Your Ref.: A/TM/592

Our Ref.: P22015

Comments of DFEH dated 23.4.2024

Comments of DEP dated 23.4.2024

Replaceable waste tank portable toilet

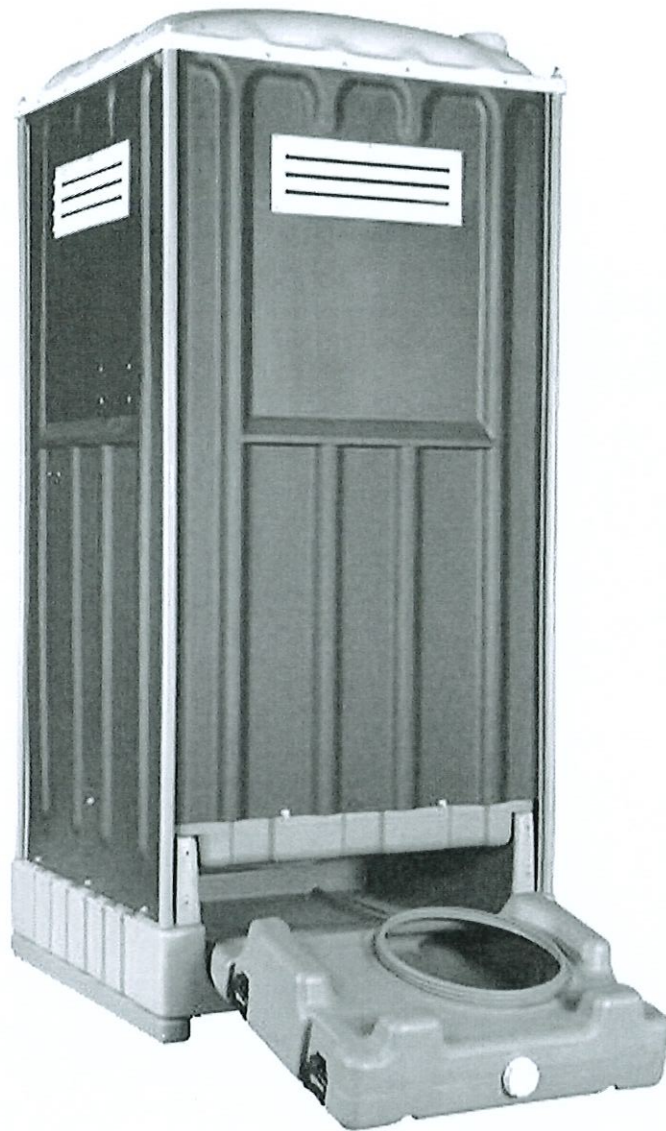
2.	R-to-C Item d - Please provide photo / catalog of the proposed portable toilet for our information. Also, the applicant is required to provide a detailed sewerage collection plan to justify the technical feasibility for our review.	Please refer to the attached photo for the proposed replaceable waste tank portable toilet. When the waste tank is full, the waste tank will be taken out and sealed by a cover. The waste tank will be taken by hand to the loading/unloading space on Lot 790 in D.D. 381 and collected by professional contractor. An empty waste tank will be placed to the replaceable waste tank portable toilet.

1:750 (A4)	Layout Plan	Goldrich Planners & Surveyors Ltd.
April 2024	Lot No. 788(part), 790(part), 793, 794 & 801 RP in D. D. 381 and Adjoining Government Land Tuen Mun, New Territories	Plan 3a (P 22015)

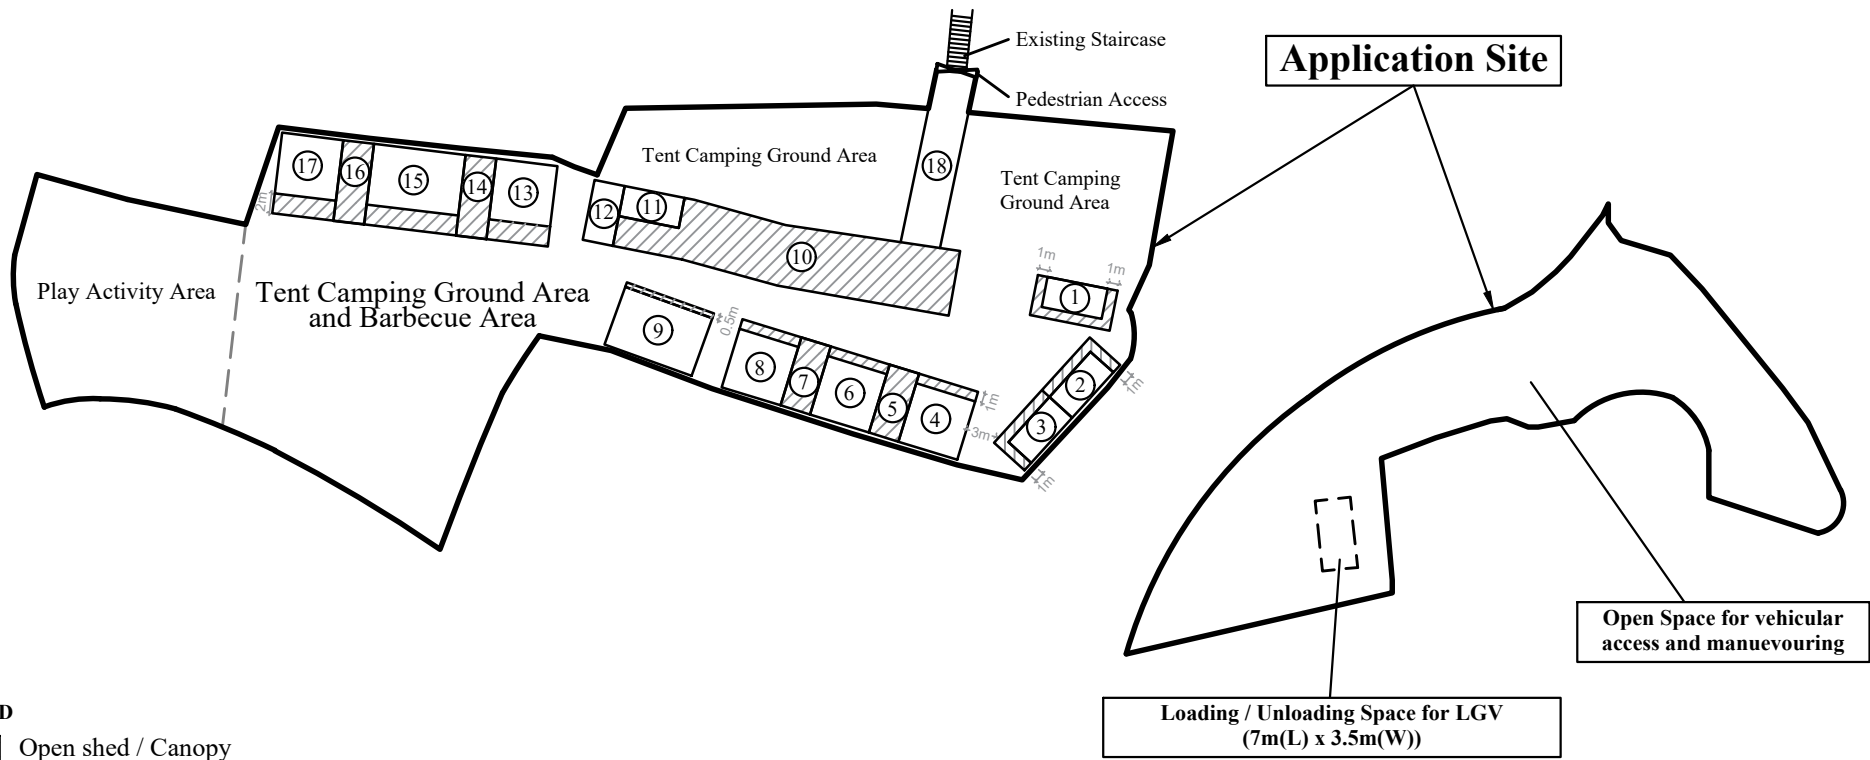
Comments	Responses
a.	Plan 3a is found missing. Also, please provide the photos of ancillary kiddie ride;	Plan 3a is attached. The applicant will not provide any kiddie ride. The location is replaced by play activity area.

2.	<p>The following irregularities have been detected by this office:</p> <p>There are unauthorized structures within the Site. Among them, some of them were covered by the planning application, whilst some of them including footbridge, storeroom, tent and porch were not covered by the subject planning application (see attached plan). The lot owner(s) should immediately rectify/regularize the lease breaches and this office reserves the rights to take necessary lease enforcement actions against the breaches without further notice.</p> <p>As regards the unauthorized structures covered by the planning application, the height and total built-over area of said structures do not tally with those proposed by the applicant on the layout plan (Plan 3 (P22015)). As such the applicant is requested to clarify the discrepancy.</p>	<p>The unauthorized structures which are not covered by the planning application have been removed.</p> <p>The unauthorized structures which are not covered by the planning application have been removed. The total built-over area tallies with the layout plan (Plan 3a).</p> <p>The height of the structures has been updated. Please refer to layout plan (Plan 3a) for details.</p>

**Plan 4a
(P 22015)**

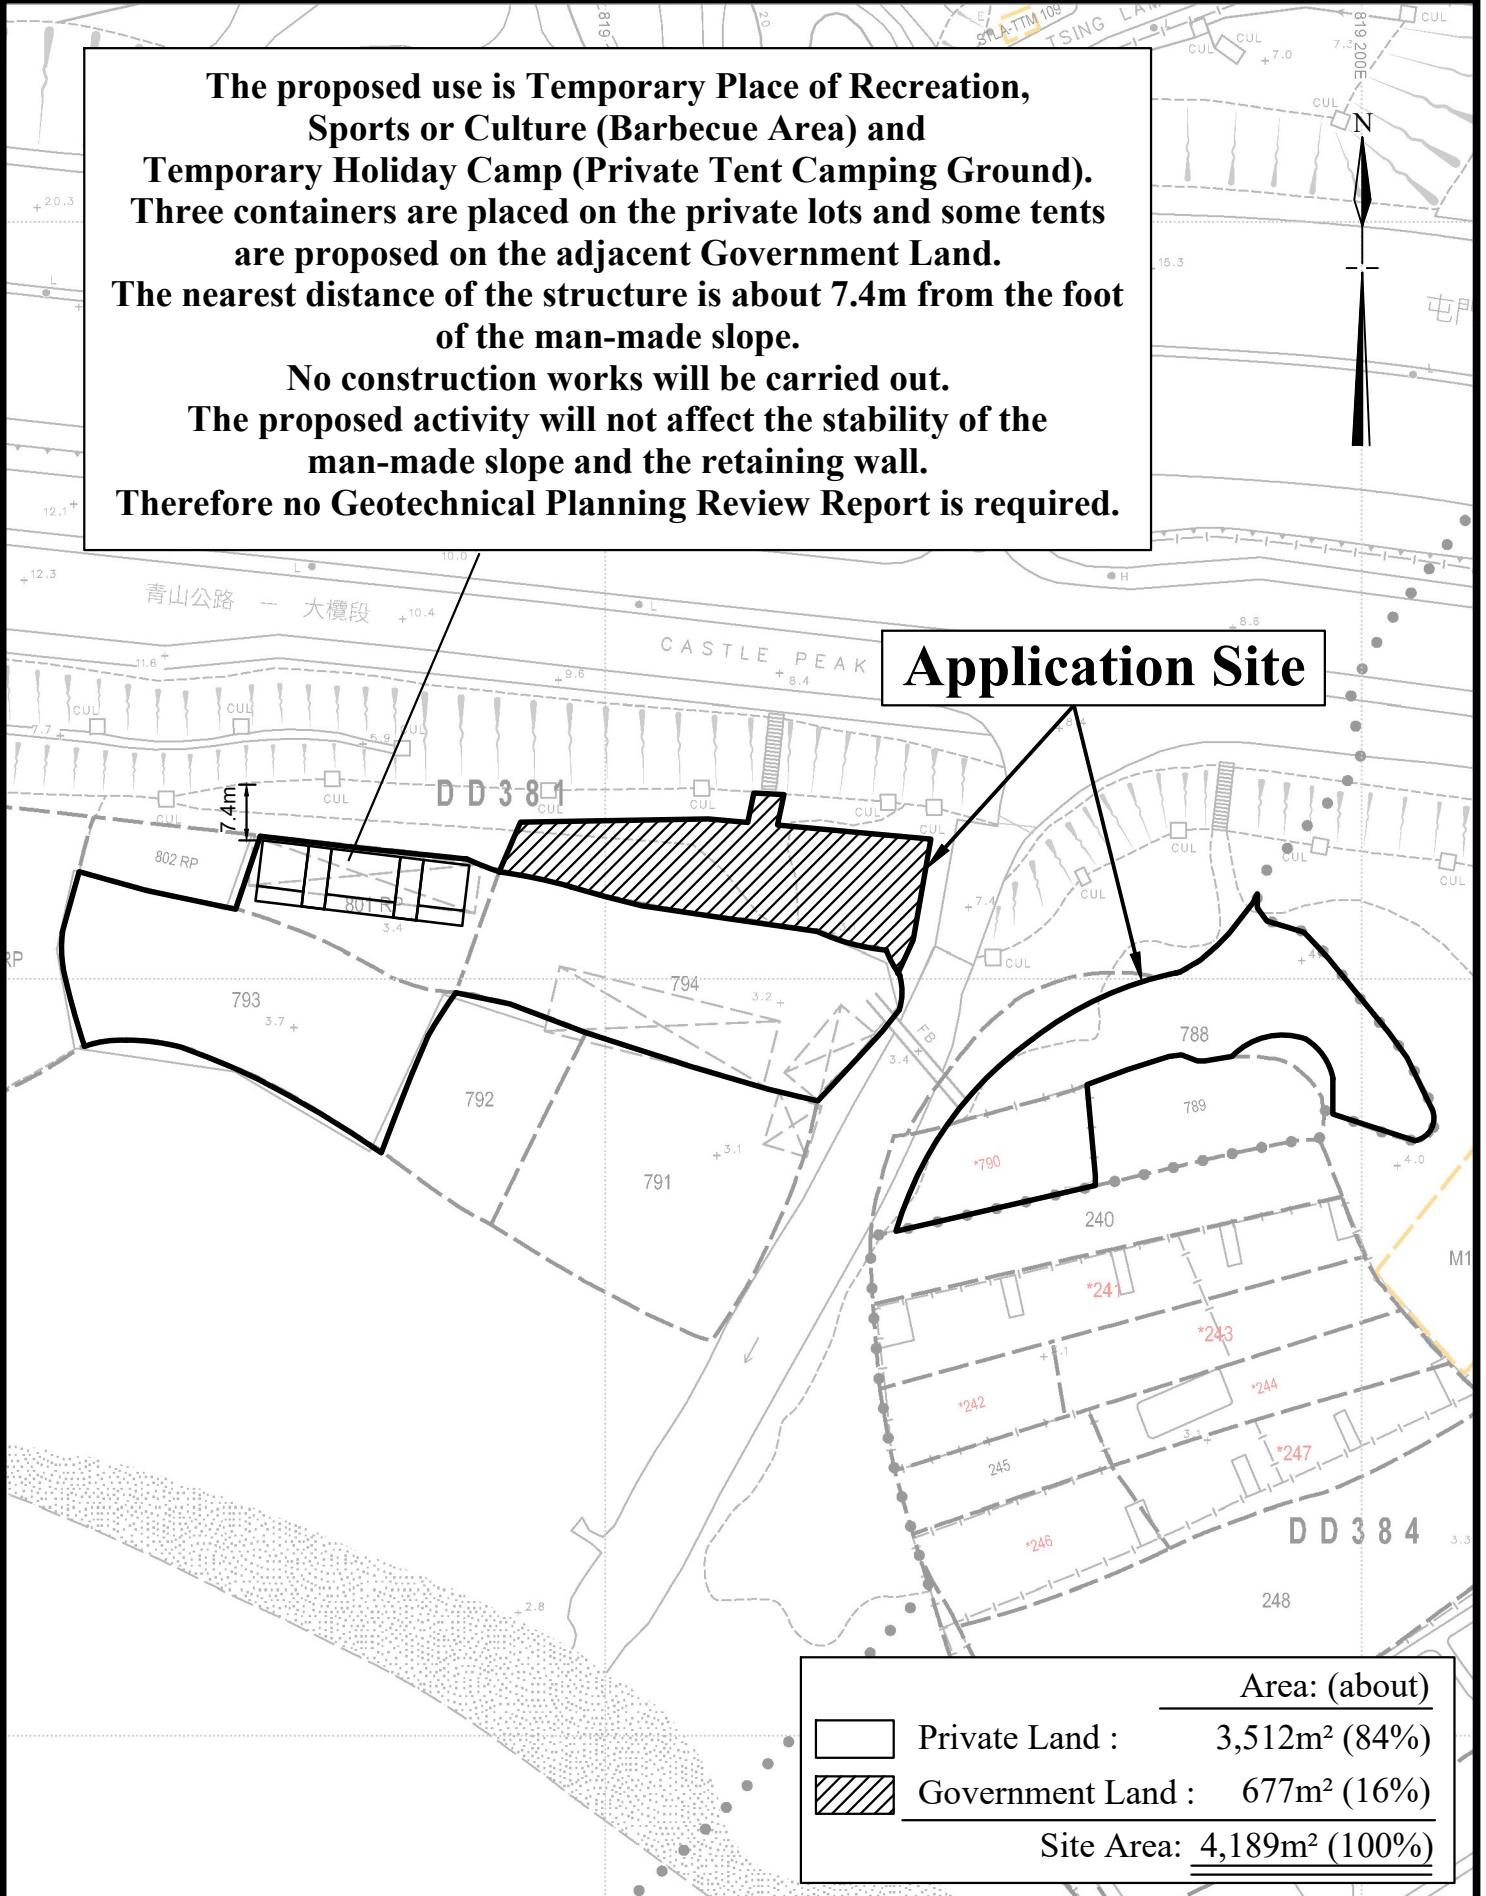
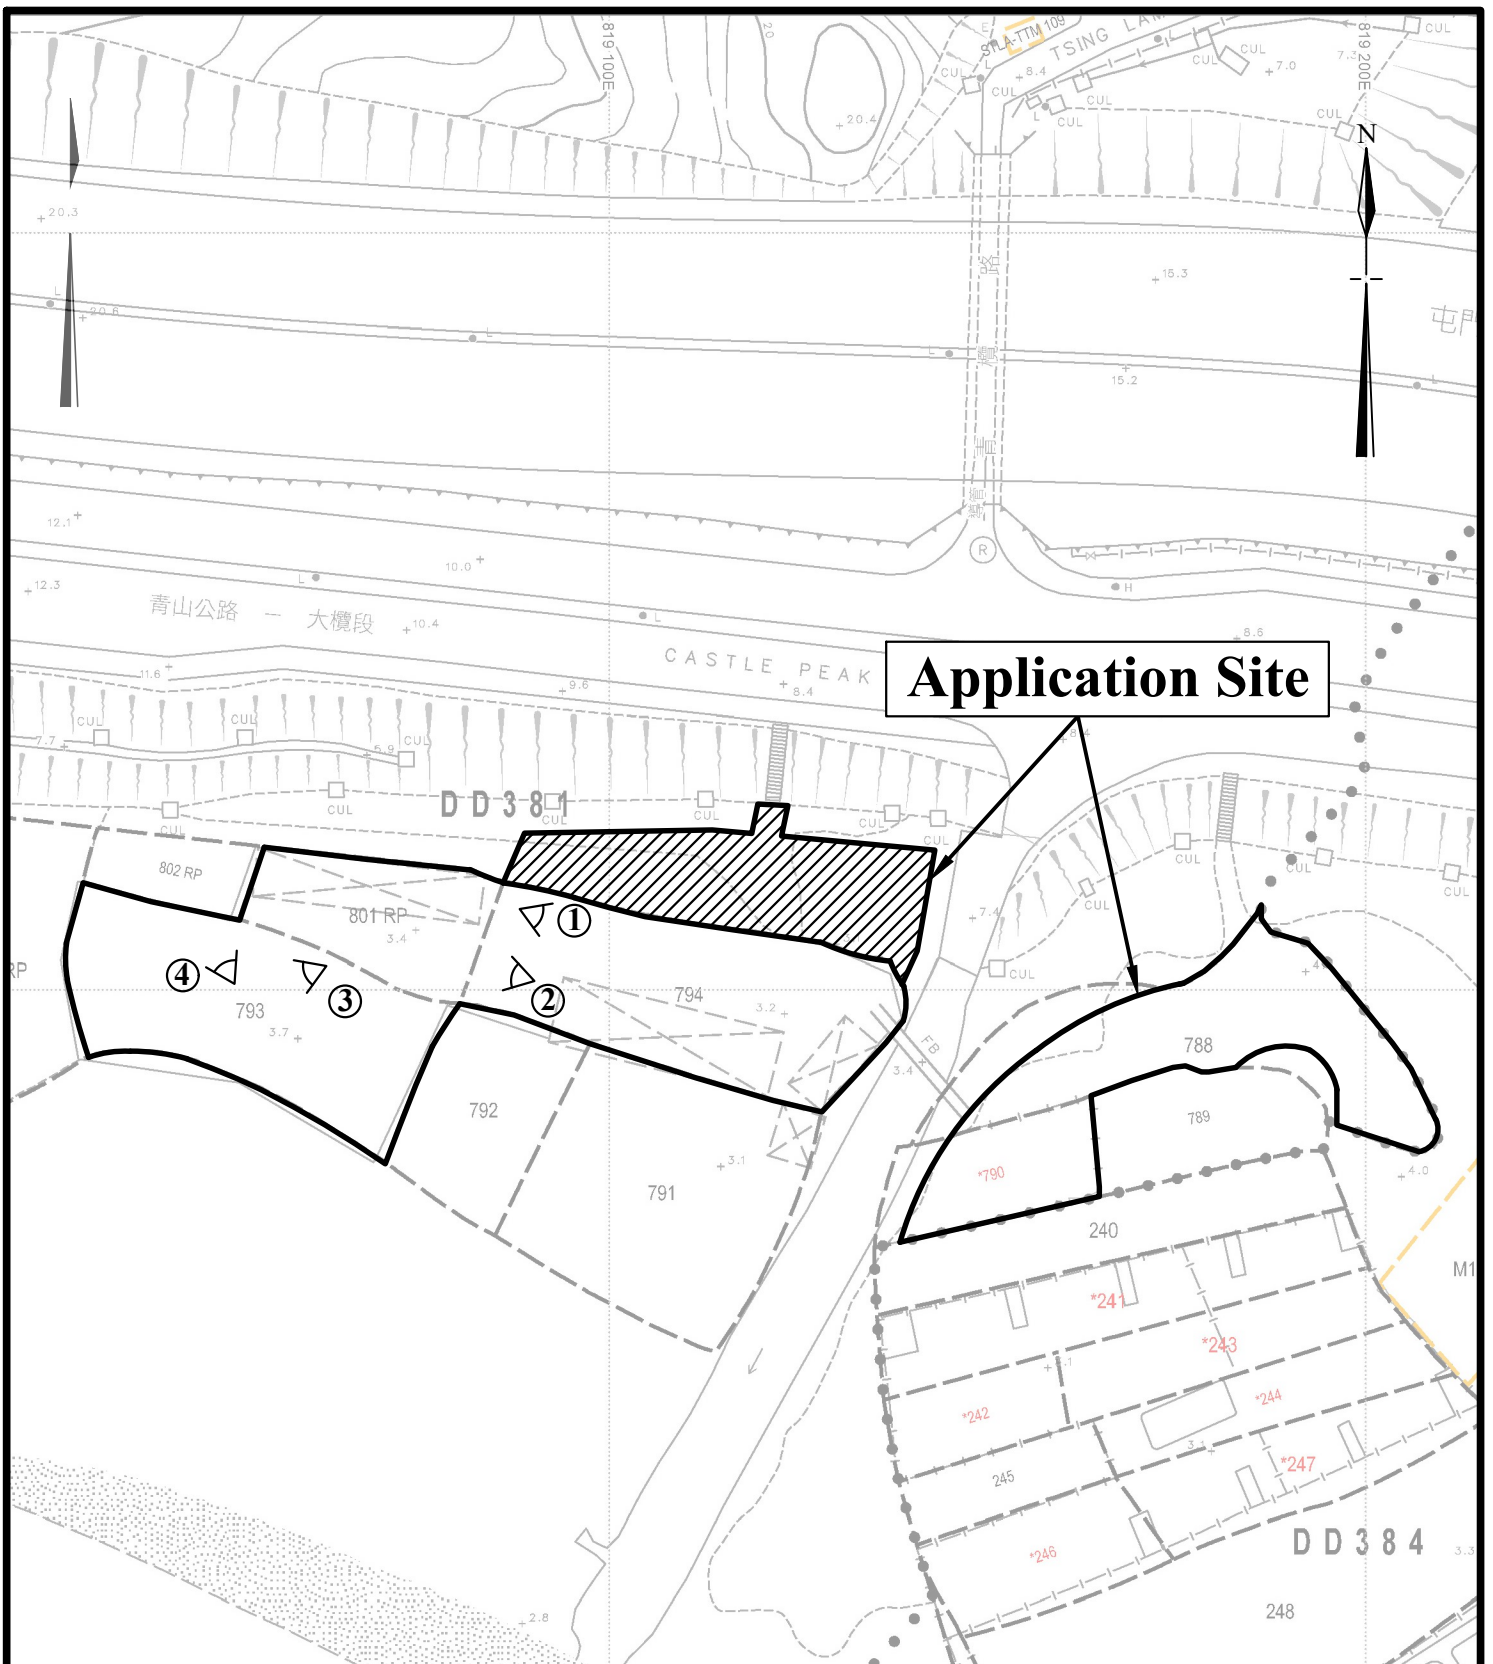
Comments	Responses
2.	<p>The subject planning application may affect or be affected by Feature No. 6SW-D/F278 (maximum height about 10m) and meets the criteria for submission of a Geotechnical Planning Review Report (GPRR) to support the application. The application is required to submit a GPRR in support of the captioned planning application. The essential contents of a GPRR are given in the attached GEO Advice Note (Annex A).</p>	<p>The proposed use is “Proposed Temporary Place of Recreation, Sports or Culture (Barbecue Area) and Temporary Holiday Camp (Private Tent Camping Ground). Three containers are placed on the private lots and some tents are proposed on the adjacent Government Land. The nearest distance of the structures is about 7.4m from the foot of Feature No. 6SW-D/F278. No construction works will be carried out. The proposed activity will not affect the stability of the Feature No. 6SW-D/F278 and the retaining wall. Therefore, no Geotechnical Planning Review Report is required. Please refer to the plan showing the distance between the foot of the man-made slope and the nearest structure (Plan 4a) for details.</p>

The proposed use is Temporary Place of Recreation, Sports or Culture (Barbecue Area) and Temporary Holiday Camp (Private Tent Camping Ground). Three containers are placed on the private lots and some tents are proposed on the adjacent Government Land. The nearest distance of the structure is about 7.4m from the foot of the man-made slope.

No construction works will be carried out. The proposed activity will not affect the stability of the man-made slope and the retaining wall. Therefore no Geotechnical Planning Review Report is required.

**Plan 6a
(P 22015)**

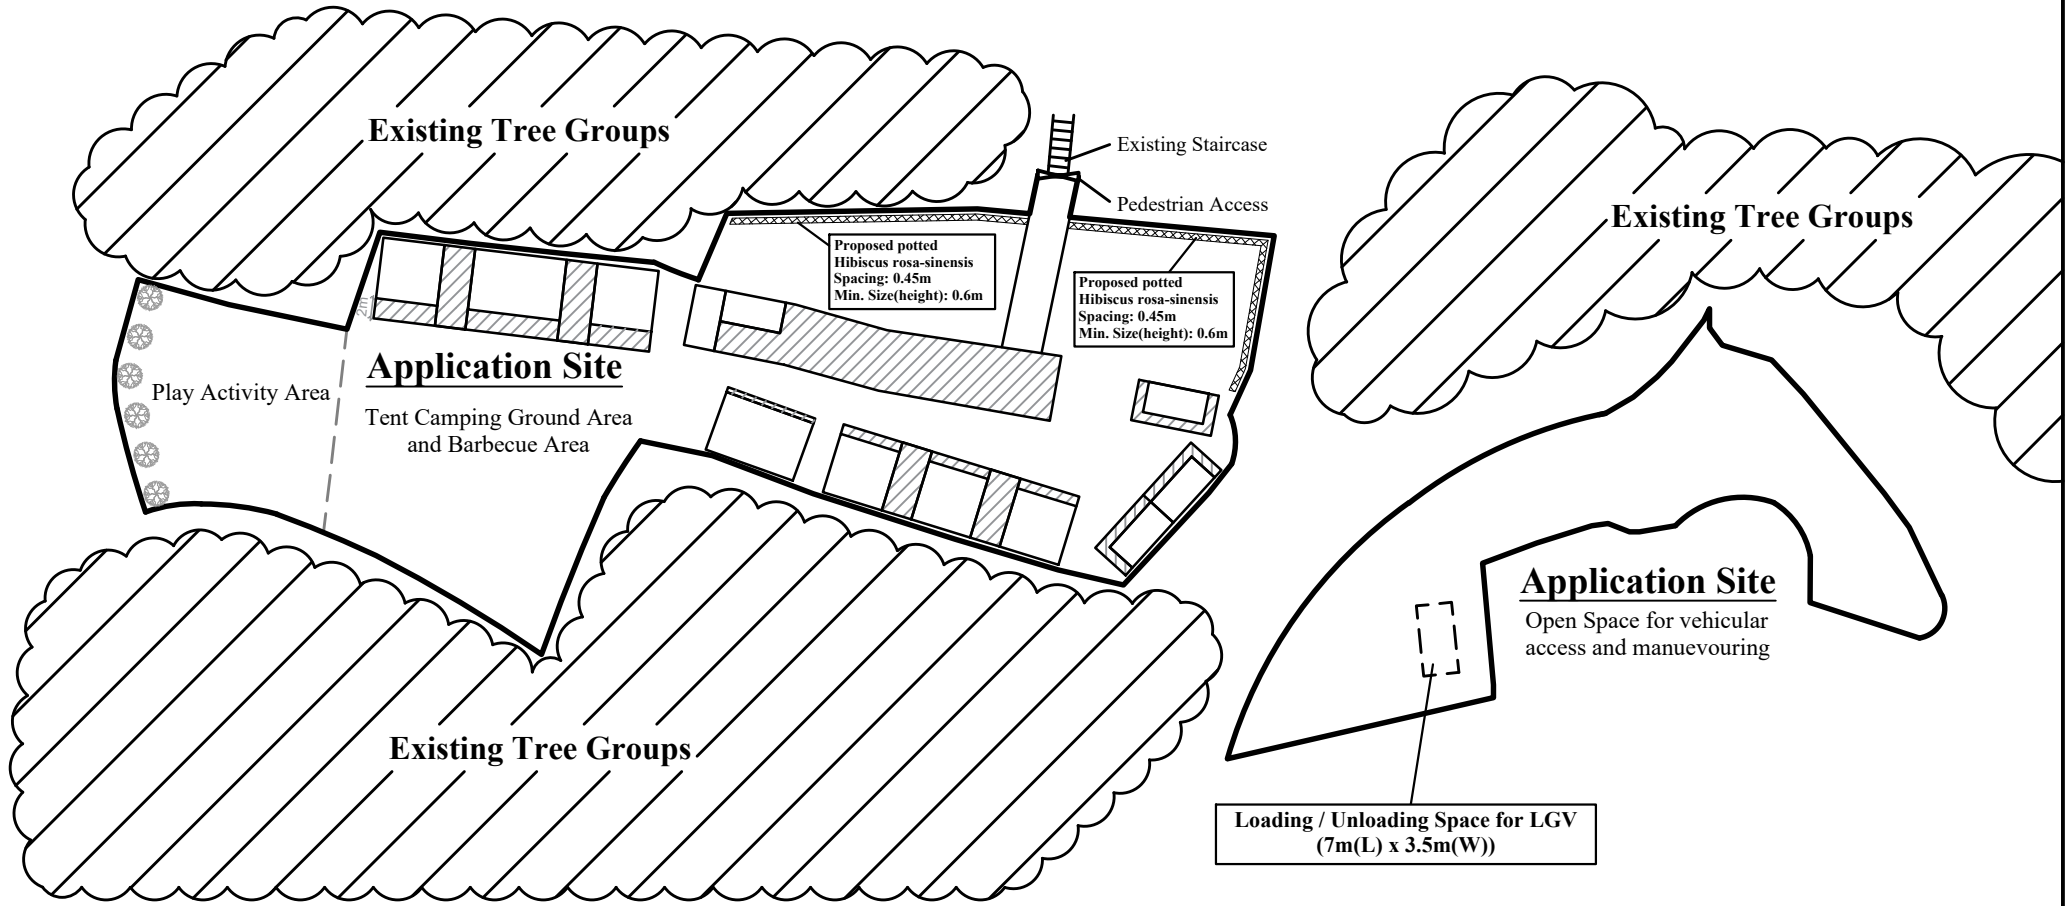
3.	Based on site photo record dated 17.03.2023 and 02.05.2024, the western part of the Site is already in operation of the applied use and the eastern part is currently occupied for car parking. By compared the site photos and aerial photos of the current site and December 2020, vegetation clearance was observed within the western portion and landscape impact has been taken place.	The site has been paved with concrete for over 10 years. There was no tree on the proposed site. The vegetation observed on the aerial photo is weeds. Please refer to the plan showing the viewpoints of photographs (Plan 6a) and the photographs taken on 24.7.2021 for details.
